Memorandum

RE: MMU Comments on Independent Consultant Interim Final Draft ICAP Demand Curve Reset Report and NYISO Staff DCR Draft Recommendations

Figure 1: B-Rated Bond Yield, August 2019 to August 2020

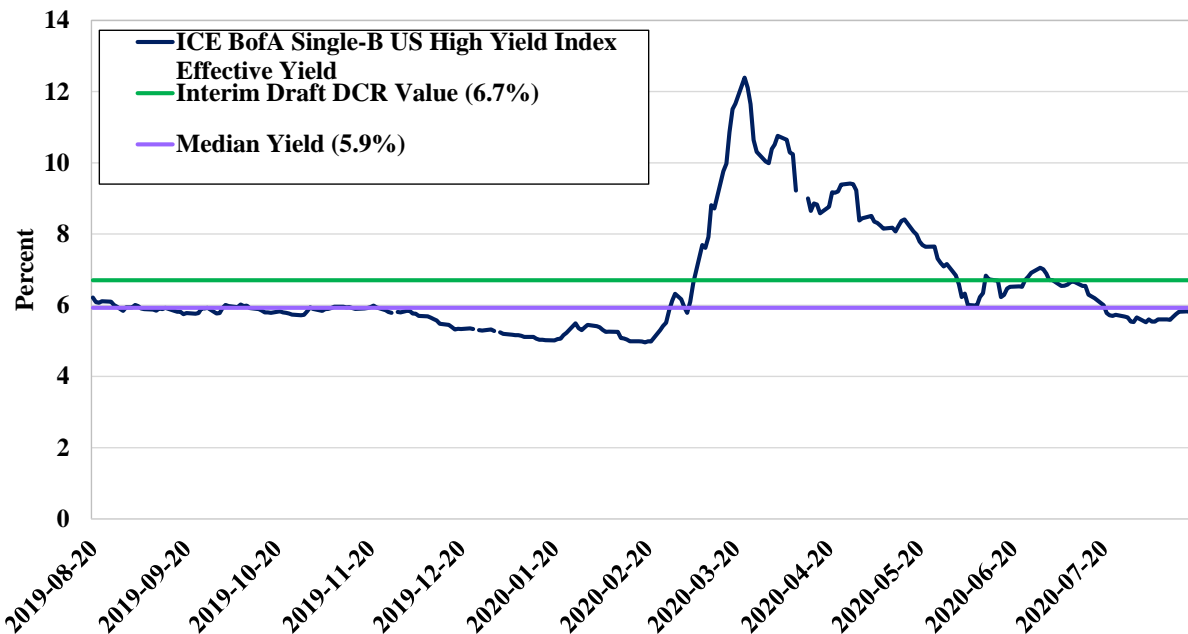
Figure 1 shows that yields began to rise sharply in late February and remained elevated in April and May. These substantial increases reflected severe liquidity issues in the credit markets that have not been sustained. When presenting their rationale for a higher cost of debt in May 2020,

the consultants pointed to the sharp increase in debt costs that occurred between March and April. In particular, the consultants highlighted costs of B-rated debt at 12.4 percent on March 23 and 9.3 percent in the week of April 21.¹ Since May, Figure 1 shows that the B-rated corporate debt benchmark has fallen considerably.² Yields then fell close to pre-COVID-19 levels in June and fell below 6 percent in August.

The purpose of this analysis is not to suggest that only the most recent yields during August 2020 should be used. Rather, it is to highlight that recent trends should provide grounds for extreme caution in considering how debt yields during a two-month period this year will relate to the cost of borrowing for the entirety of the 2021-2025 demand curve reset period. A principled approach to establishing all demand curve parameters is to seek values that reflect a reasonable expectation of the parameter over the reset period. Such an approach to calculating the cost of debt (e.g., a rule-based method such as using the median over a significant period of time) will avoid giving undue weight to short-term market fluctuations.

While the 6.7 percent cost of debt recommended by the consultants in their Interim Final Draft Report is more reasonable than the 7.7 percent draft recommendation, it is still significantly above what a historical review of benchmark rates would support. Median yields over the historical periods shown in Table 2 are consistent with our recommendation to assume a cost of debt between 6.0 and 6.5 percent. It is appropriate for the historical costs used to establish this assumption to include data since the onset of COVID-19, but not to assign it disproportionate weight to this period. In fact, given that current yields are below 6.0 percent, it would be most reasonable to assume a cost of debt at the low end of this recommended range.

Figure 2: Cost of Reserves in Draft DCR Model vs. Historical Average DA Reserve Offers

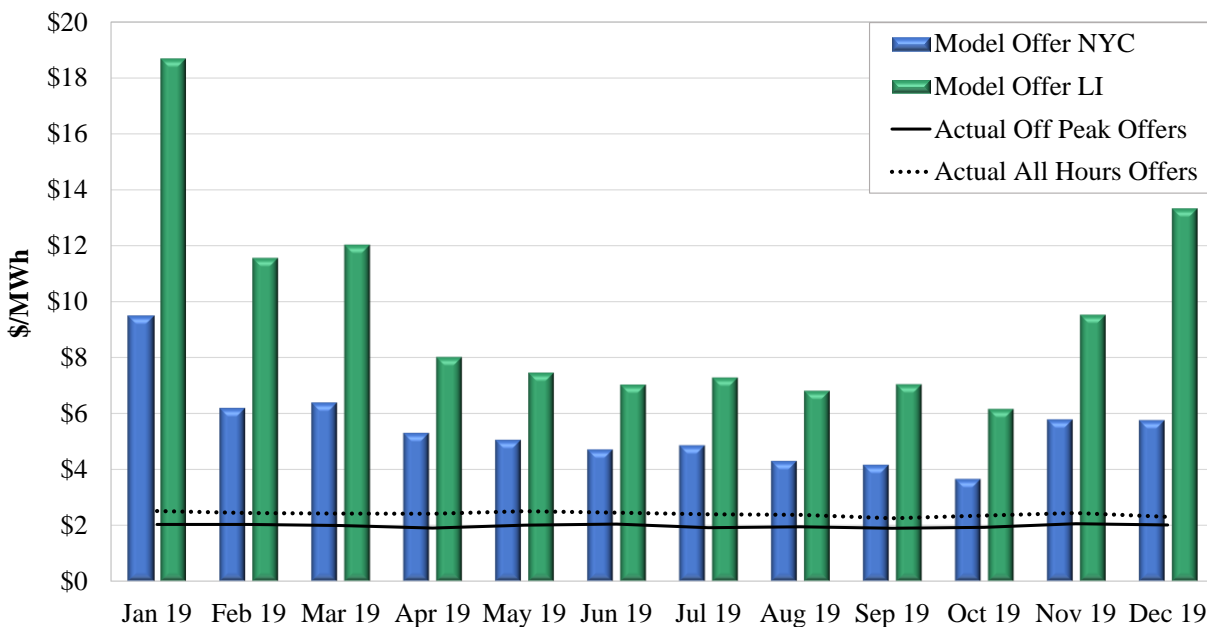
Figure 2 shows that the capacity-weighted average reserve offer was \$2.0/MWh during off-peak hours, when offers are likely to be more competitive, and \$2.4/MWh in all hours. Typical reserve offers had little variation across months. By contrast, the draft model methodology implied an average cost of \$6/MWh in Load Zone J and \$9/MWh in Load Zone K in 2019, with monthly averages as high as \$9 in Load Zone J and \$18/MWh in Load Zone K.

Based on this data, we recommended that the consultants replace the fuel-based cost of selling reserves in the day-ahead market with a constant cost of \$2.0/MWh. This will align the modeled cost with typical offer prices for similar existing units in New York. In the Interim Final Draft Report the consultants accounted for this recommendation and modified the cost of reserves for dual fuel units in their Net E&AS Model to \$2.00/MWh.

Figure 3: Historical vs. Backcast Operation for Zone C Gas-Fired Plants

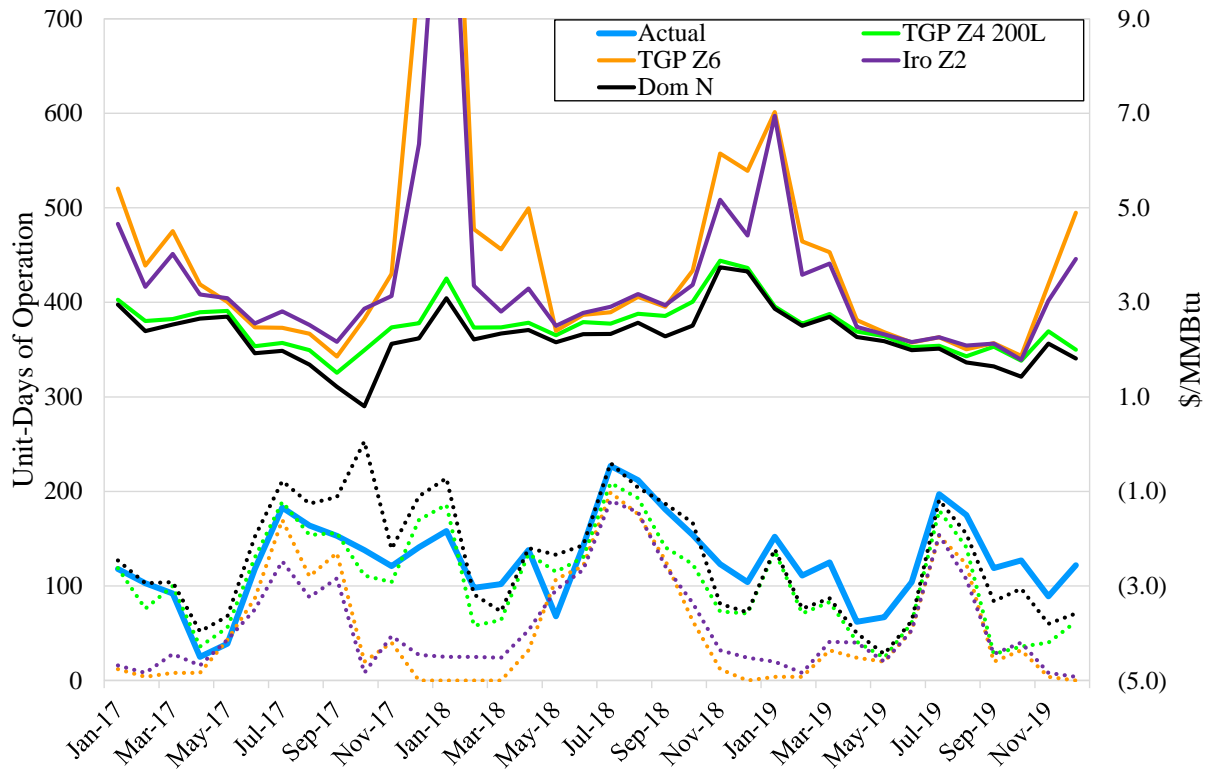
Figure 3 compares the actual number of days of historical operation for nine gas-fired units in Zone C to a backcast simulation for each unit under alternative fuel price assumptions. The simulation was performed using hourly day-ahead and real-time historical LBMPs at each plant node, daily gas indices for each hub from SNL, and plant parameters derived from unit-specific reference level data and plant-level EPA data. The lower portion of the chart (left axis) shows the actual combined days of operation compared to predicted days of operation using each gas hub price (dotted lines). The upper portion of the chart (right axis) shows average gas price for each index used in the analysis. Generator results are presented in aggregated form because confidential unit-level reference data was used for the simulation.

Of the four alternative gas hubs used, TGP Z4 200L and Dominion North were better predictors of actual Zone C plant operation than TGP Z6 and Iroquois Z2. Notably, this result holds in winter months, when prices at TGP Z6 and Iroquois Z2 often spike to high levels. During these periods, plants in Zone C operated much more often than would be expected if facing fuel costs at the TGP Z6 or Iroquois Z2 levels. Existing plants may have unique fuel supply arrangements that do not necessarily align with what the Demand Curve unit could expect to obtain.¹⁰ However, this analysis indicates that gas priced at a discount to TGP Z6 and Iroquois Z2 hubs is available in central New York, including during winter months.

Figure 5: Operational Available Capacity on TGP Segments Entering New York

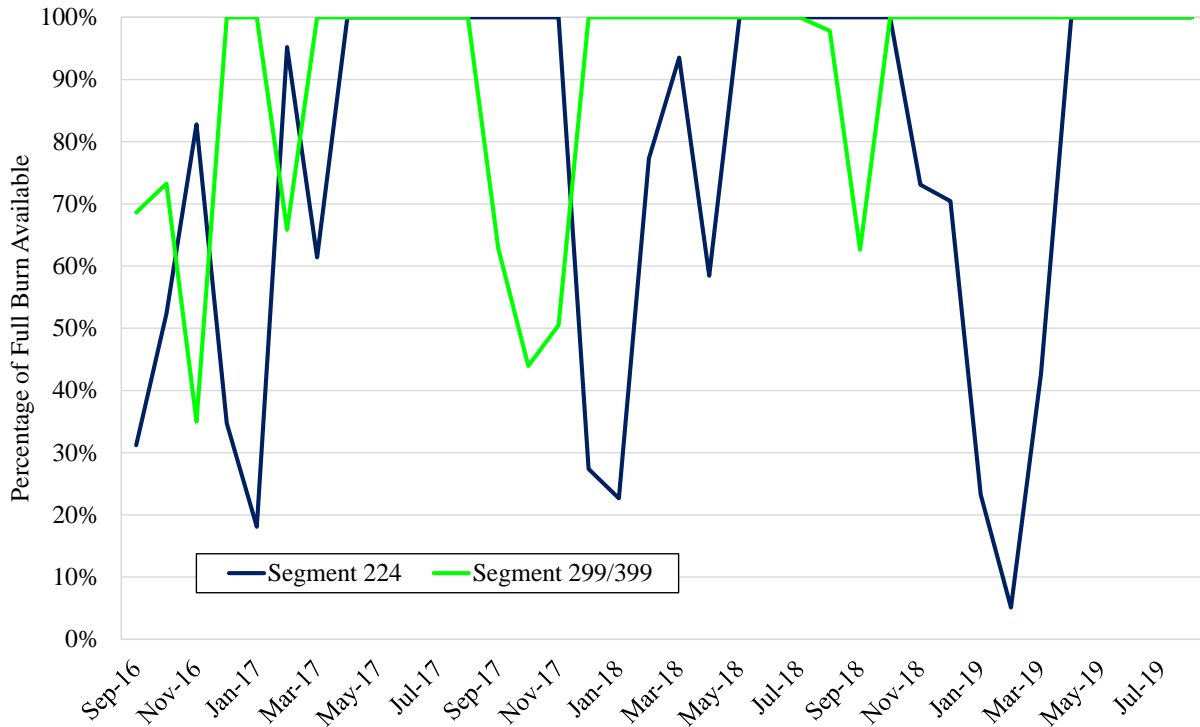
Figure 5 shows the historical average daily operational available capacity on TGP segments entering New York from Zone 4, as a percentage of the daily gas that would be required for the peaking plant to operate for 24 hours (approximately 75,000 Dth).¹² Capacity on Segment 224 connecting TGP Z4 200L to western New York was available in most months, but was frequently severely constrained in winter. Capacity on Segments 399 and 299 connecting TGP Z4 300L to central New York had greater availability. However, a review of daily critical notices issued by the TGP pipeline indicates that interruptible transport on both the 224 and 299 segments is frequently subject to restriction, particularly in winter. This data suggests that the purchase of gas at the TGP Z4 200L hub and transport to New York using interruptible service is often not possible during winter. In such months, the use of TGP Z4 200L as the gas hub may overstate net energy revenues of the peaking unit.

An alternative to offset the potential over-estimate of E&AS revenues is to use the Niagara hub in winter months. New York consistently exports gas to Canada via the Niagara interconnection between TGP and TransCanada. Hence, the price at Niagara can be seen as a proxy for the cost of acquiring gas at points in Zone A upstream of the Niagara spurline (segments 295 and 296). Data on operational available capacity indicates that segments in between zones A and C (segments 230 and 233) are rarely constrained, while segments further downstream in between zones C and F are frequently constrained in winter. Hence, the use of the Niagara price during winter months is reasonable for the region in between the bottleneck separating Zone 4 from New York and the bottleneck separating central from eastern New York.

The consultants’ recommended gas cost of TGP Z4 200L + \$0.27 is appropriate for Zone C during much of the year. It is important that the selection of gas hub recognize that there is a lower cost of fuel in western and central New York than in eastern New York, including in winter months. Gas hubs associated with eastern New York such as TGP Z6 and Iroquois Z2 are therefore not appropriate. Direct transport from the TGP Z4 200L region to Zone C is often not available in winter, which may result in overstated net E&AS revenues if this hub is used in all months. Therefore, we recommend that the consultants use the Niagara price hub plus \$0.27 in winter months and TGP Z4 200L plus \$0.27 in all other months.

Figure 7: Operational Available Capacity on Algonquin Millennium Mainline Segment

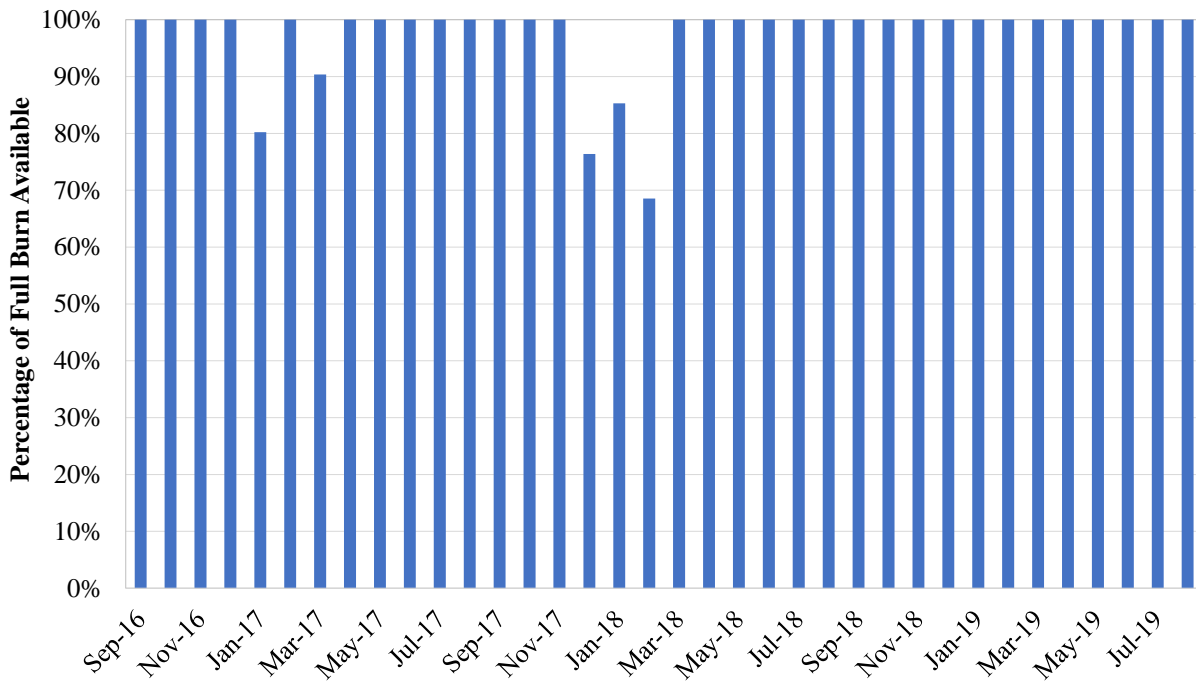
Figure 7 shows the average daily operational available capacity on the Algonquin pipeline segment passing through the Millennium Mainline station in Ramapo, NY as a percentage of the daily gas that would be required for the peaking plant to operate for 24 hours (approximately 75,000 Dth).¹⁷ Average available capacity exceeded the maximum daily burn in most months, and covered a high percentage of maximum daily burn even in cold winter months. This is likely a conservative measure, as a peaking unit typically will not generate for all hours of a day. Furthermore, as noted above, the recommended peaking plant design for Rockland County is dual fuel and, therefore, also has the option to run on oil in the minority of days when gas may not be available.

Hence, we consider the consultants’ use of TETCO M3 plus \$0.27/MMBtu (along with the assumed intraday premium or discount of 10 percent) to be appropriate for the Rockland County unit, while use of the Algonquin Citygate or Iroquois Zone 2 hubs would be inappropriate given the county’s proximity to the TETCO M3 market zone.
